Title & Document Type: 8405A Vector Voltmeter Operating and Service Manual

Manual Part Number: 08405-90024

Revision Date: May 1971

VECTOR VOLTMETER 8405A

Figure 2. Schematic of A11 IF Sampler Assy (08405-6011)

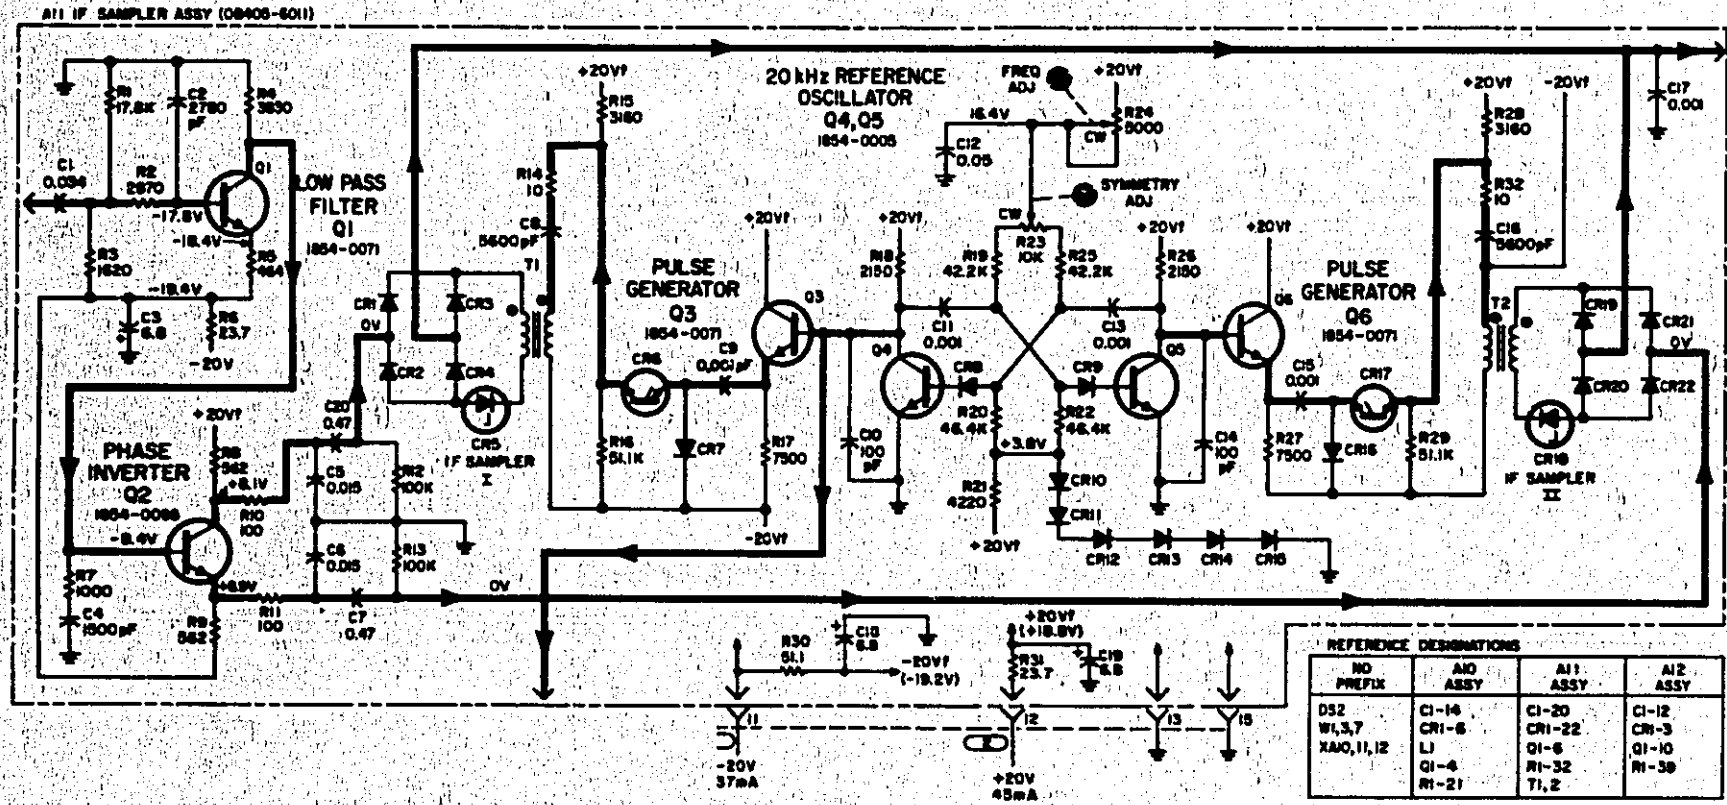
CHANGE 10: a.) All Sampler Assy 08405-6011 is different (see Figure 2) than shown in Figure 7-15.

b.) In the event of A12R27 failure, it is recommended that the value be changed.

From: 0698-3446 R:FXD 383OHM 1% 1/8W
 To: 0686-4315 R:FXD 430Ω 5% 1/2W

Figure 7-18. Power supplies (Partial Schematic) (CHANGE 7)

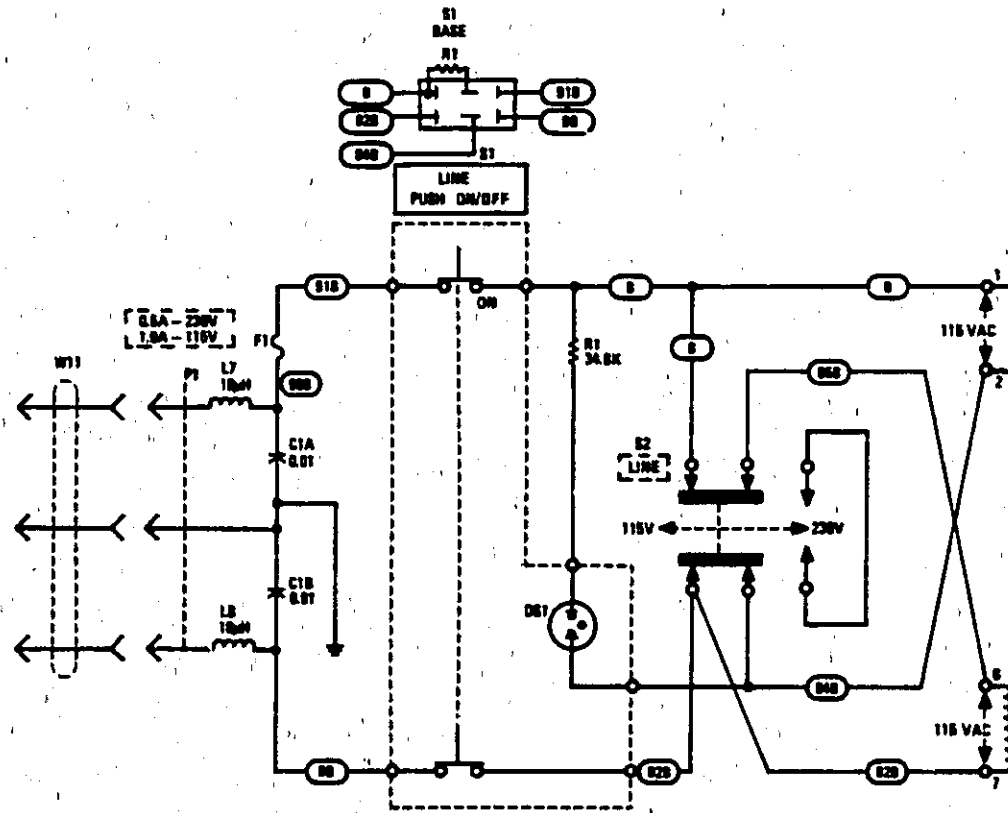
Change primary power circuit per Figure 7-18 in this change sheet (CHANGE 7).

P/O Figure 7-15(b). Schematic Diagram, Automatic Phase Section (Part 1) (CHANGE 11)

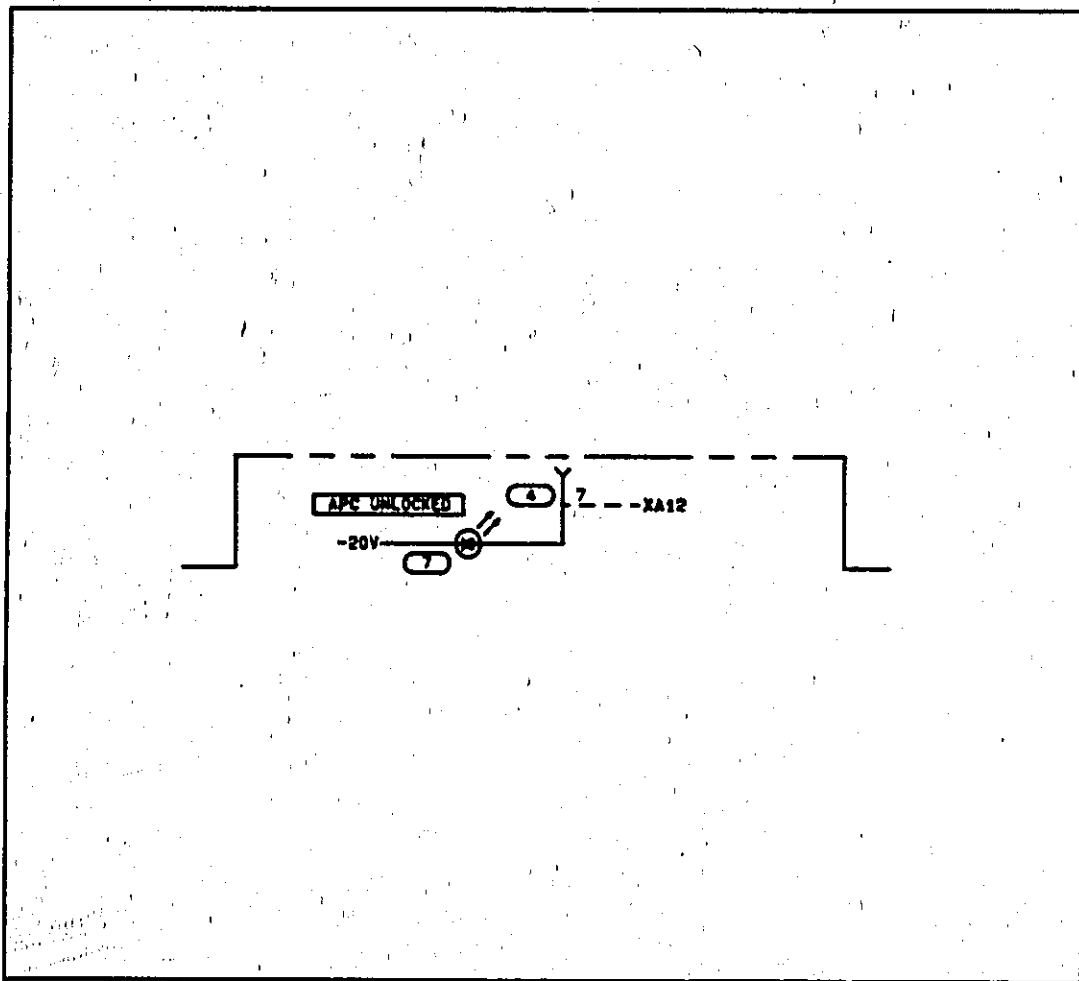
Change the A12DS2 symbol using the partial schematic in this document [P/O Figure 7-15(b) (CHANGE 11)].
